PRODUCT SERVICE BULLETIN

FIX AS FAIL: B/BX/V/ZD-Series; Defective Injection Pump

Product Line: B-Series, BX-Series, V-Series, ZD-Series

Model: B2301, B2601, BX2670, RTV-X1100, RTV-X1120, RTV-X1140, ZD326, ZD331, and ZD1211

(a) Stopper Ball

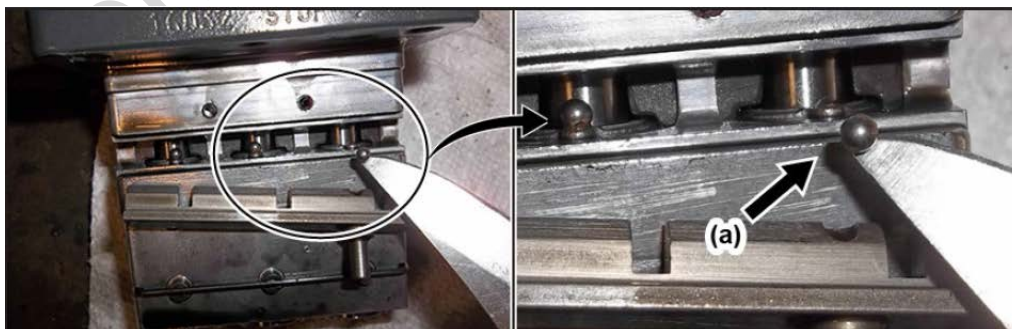
Injection pump may fail due to the insufficient weld penetration of the stopper ball (see example below). This will cause the injection pump to have issues controlling the amount of fuel injected. This can cause failure such as a loss of power, the unit blowing black smoke, and the engine not shutting off properly.

If this failure occurs, replace the Assy Pump, Injection with the below improved pump per the workshop manual for the affected model.
